Waverly Central School District
Waverly, New York

Additions and Alterations to
Elm Street Elementary School
Phase 2

BID Addendum No. 2
to
Drawings and Project Manual

August 28, 2026

Temp Conditions Data Closet Plan

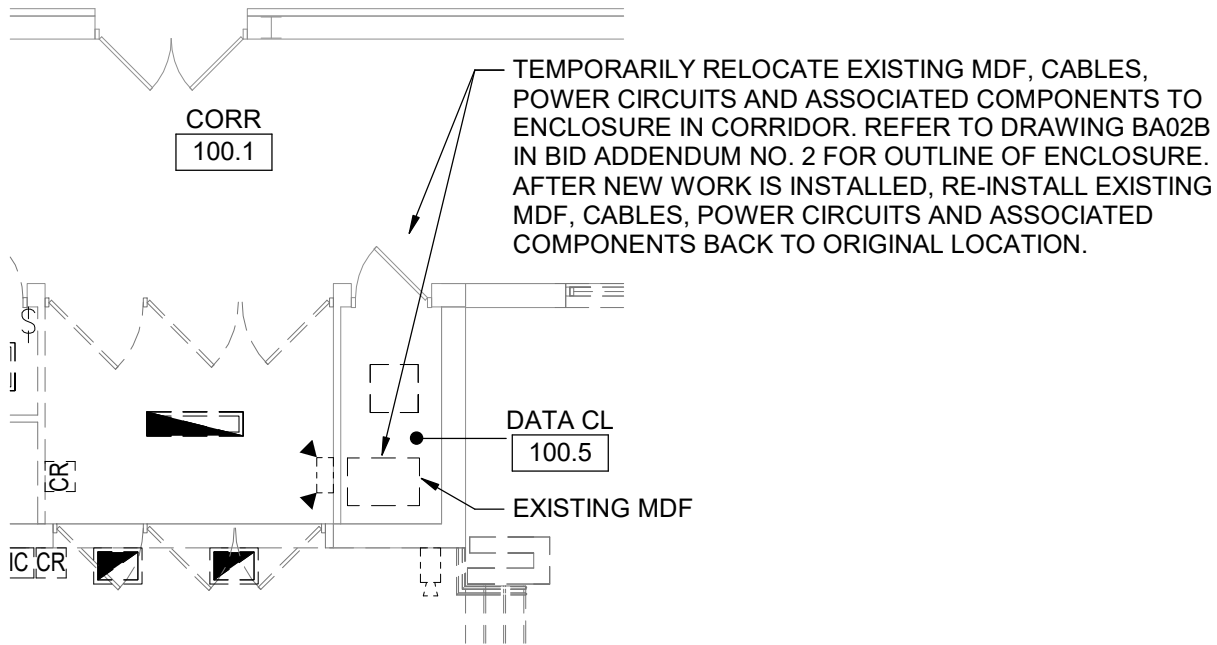
ITEM 2-C-7: Refer to DRAWING BG201

1. Detail 1, **AMEND** as shown on Drawing BA02B attached to this addendum.

Partial First Floor Demolition Plan - Area B

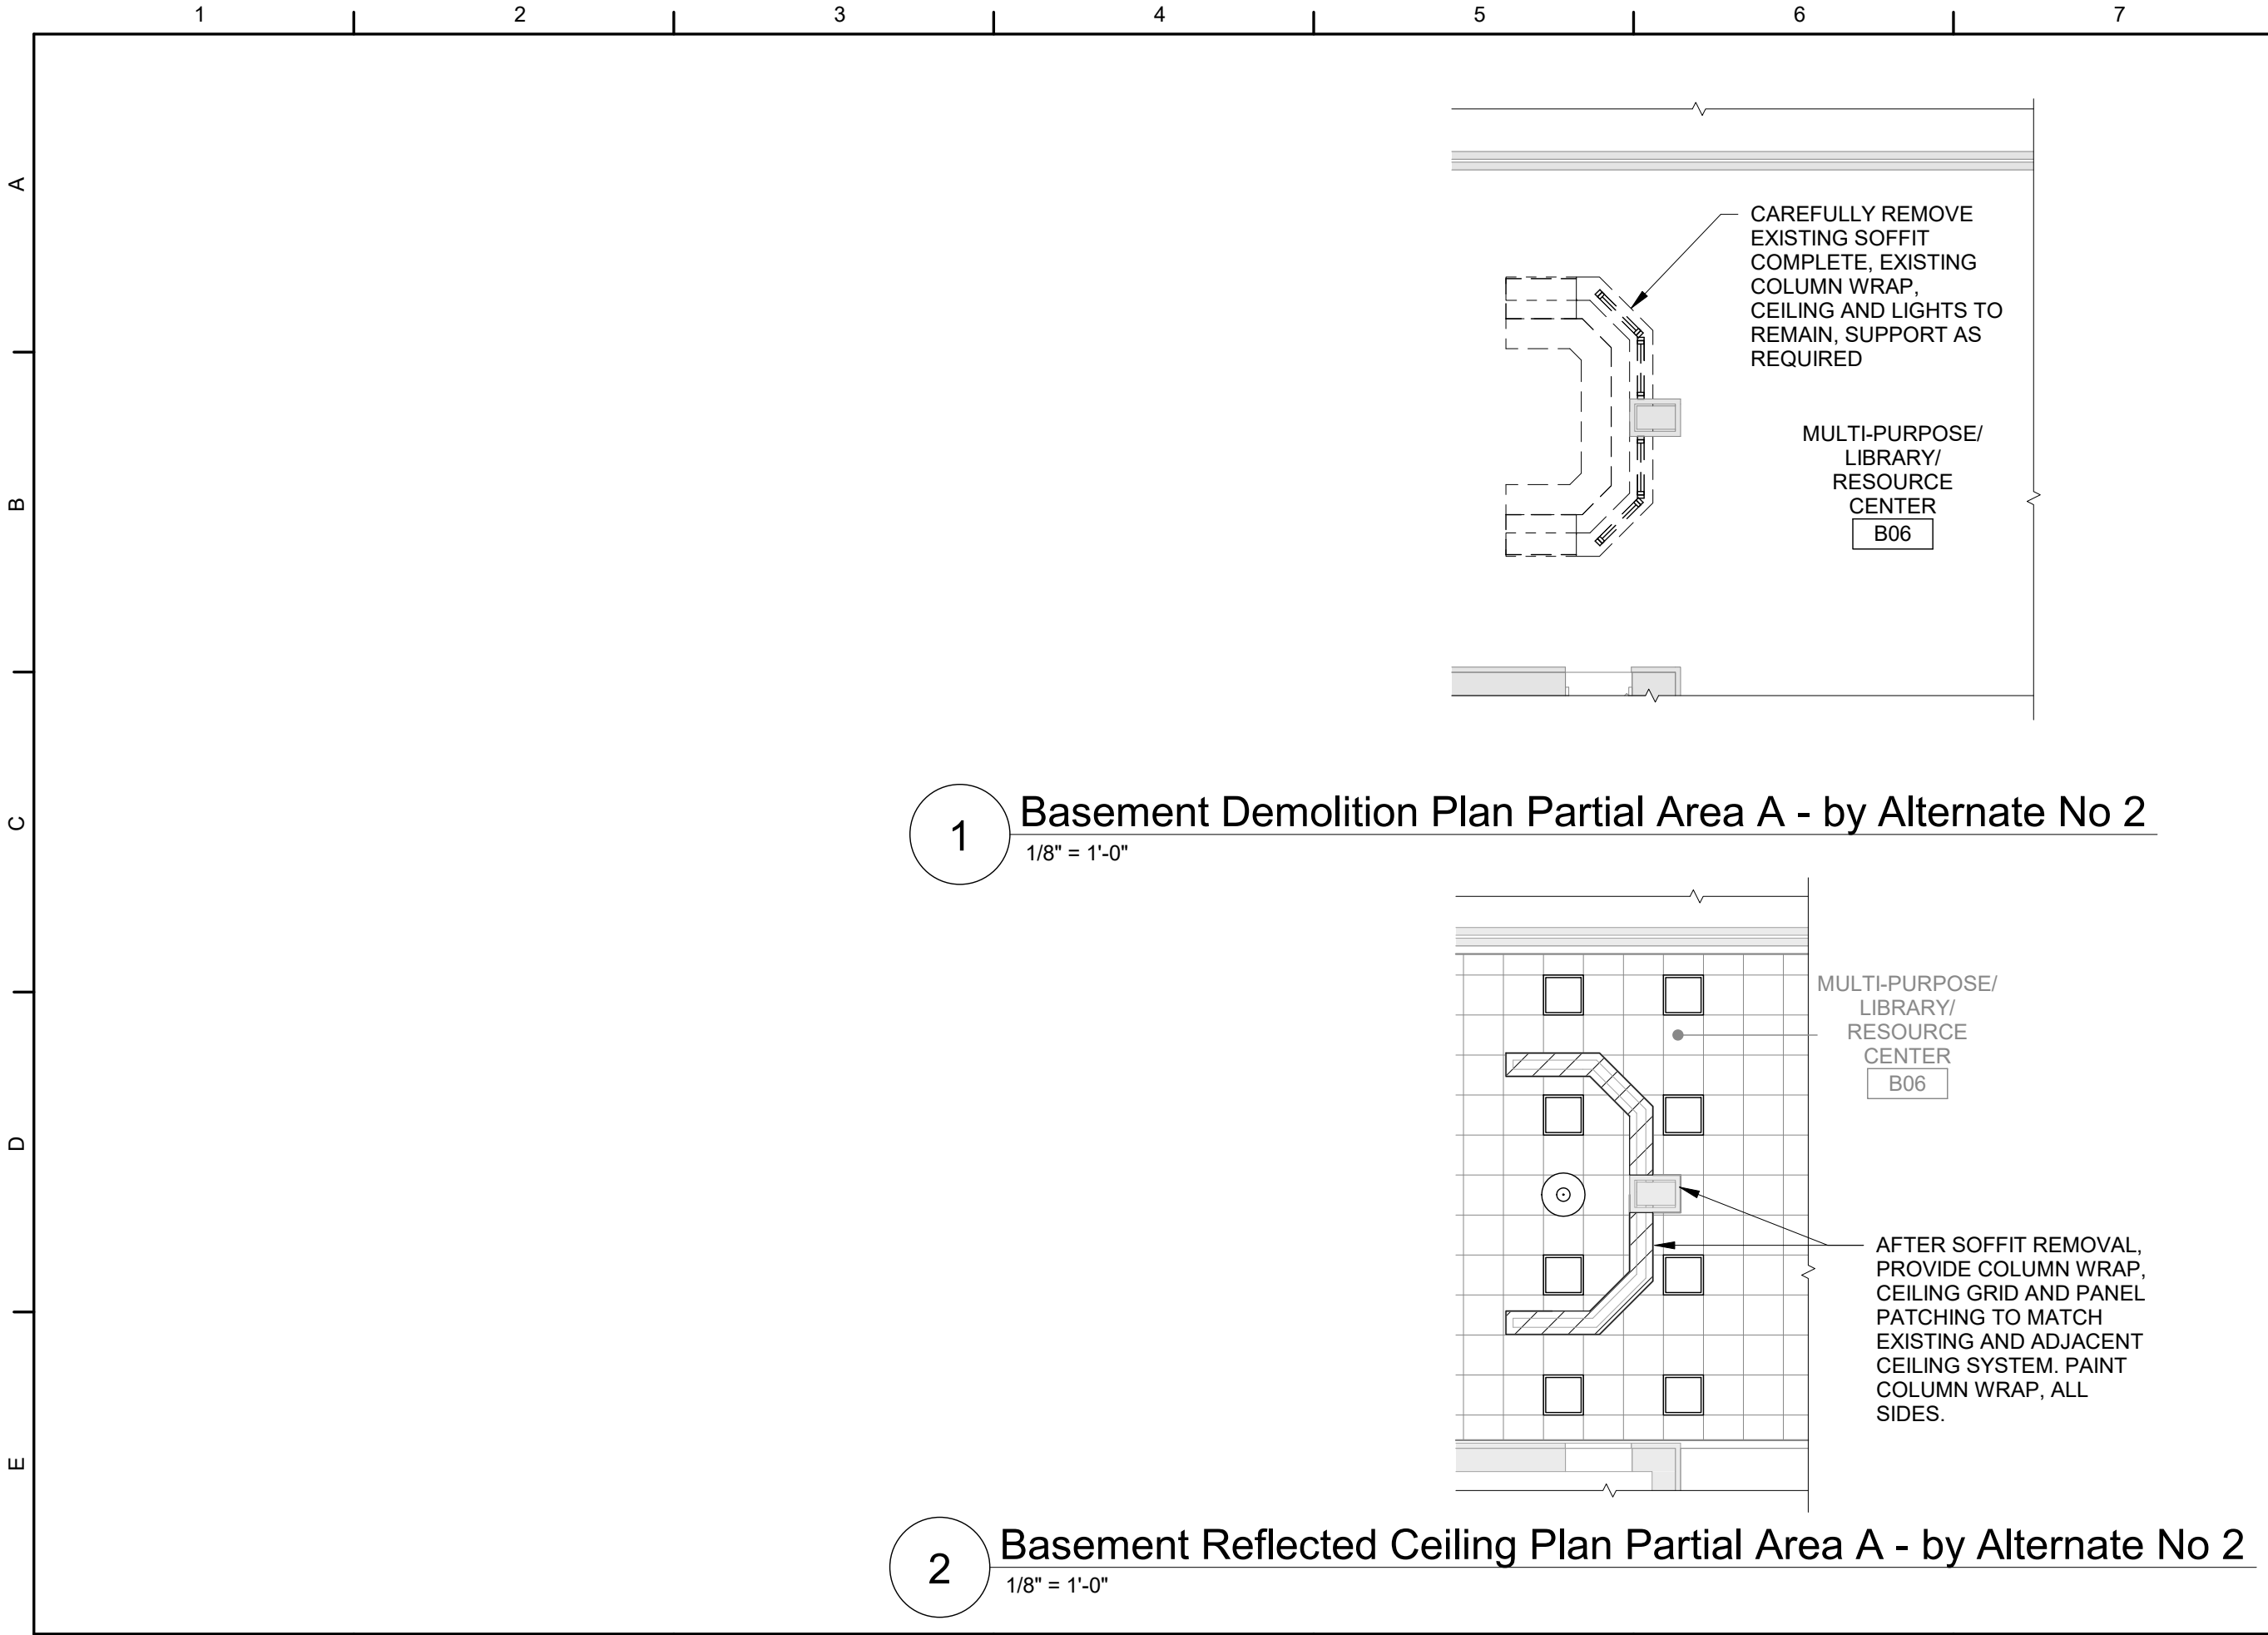
ITEM 2-C-16: Refer to DRAWING BE100

1. Detail 1, AMEND as shown on Drawing BE01B attached to this addendum.

Library Ceiling Work - by Alternate No 2

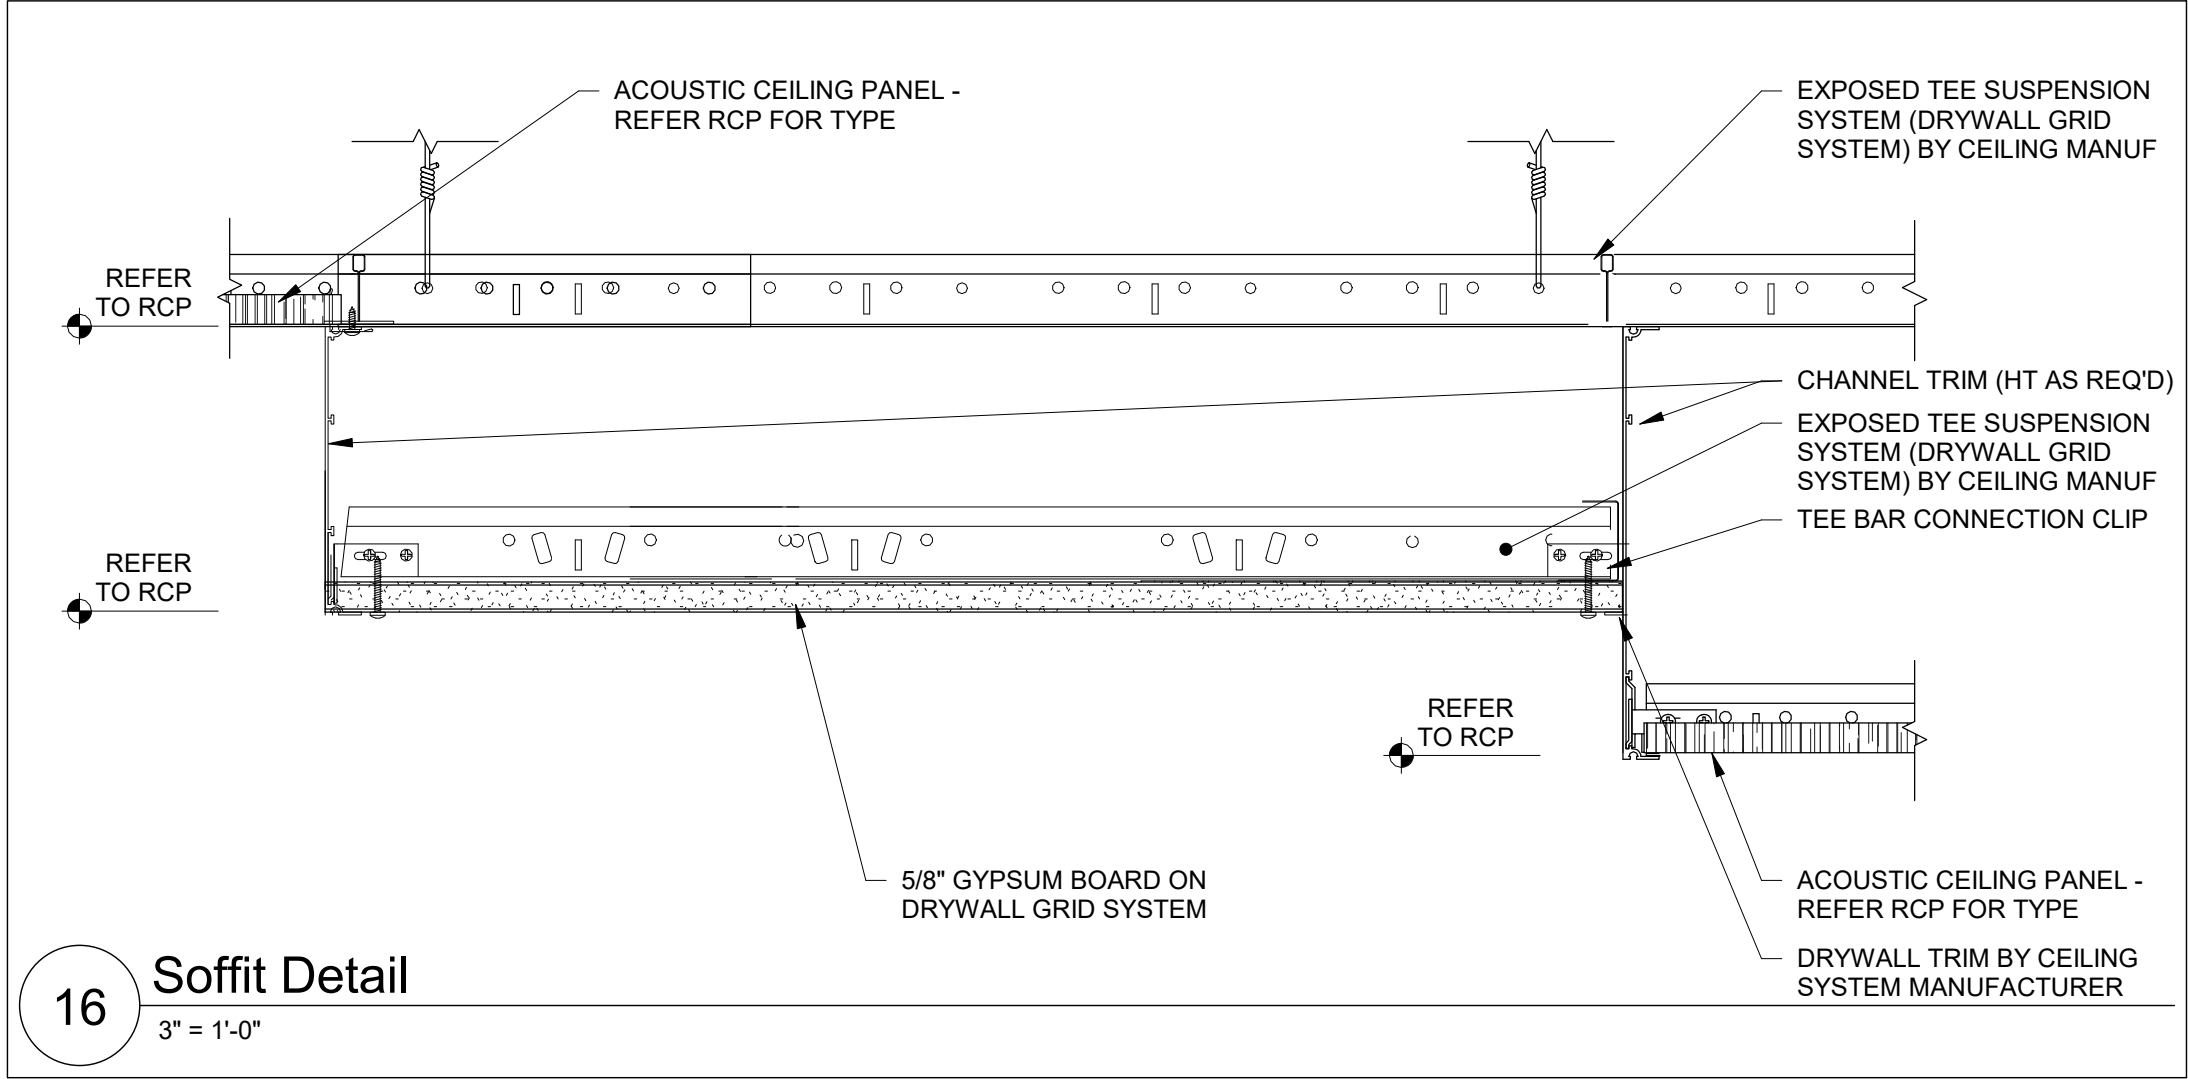
“B. Alternate No. 02 – Library Ceiling Work:

1. This Alternate affects Contracts, as follows:
 - a. General Contract: Remove existing soffit and patch existing ceiling as shown on BA01B.
 - b. Plumbing Contract: Not applicable.
 - c. Mechanical Contract: Not applicable.
 - d. Electrical Contract: Not applicable.
 - e. Food Service Contract: Not applicable.”.

ITEM 2-C-8: Refer to DRAWING BA100

1. **ADD** Partial Demolition Plan 1 as shown on Drawing BA01B attached to this addendum.

ITEM 2-C-9: Refer to DRAWING BA160

1. **ADD** Partial Basement Reflected Ceiling Plan 2 as shown on Drawing BA01B attached to this addendum.
2. Detail 1, Health Suite 110, **AMEND** detail tags at soffits that run N/S in center area of room, to read as follows:
“16/BA03B”
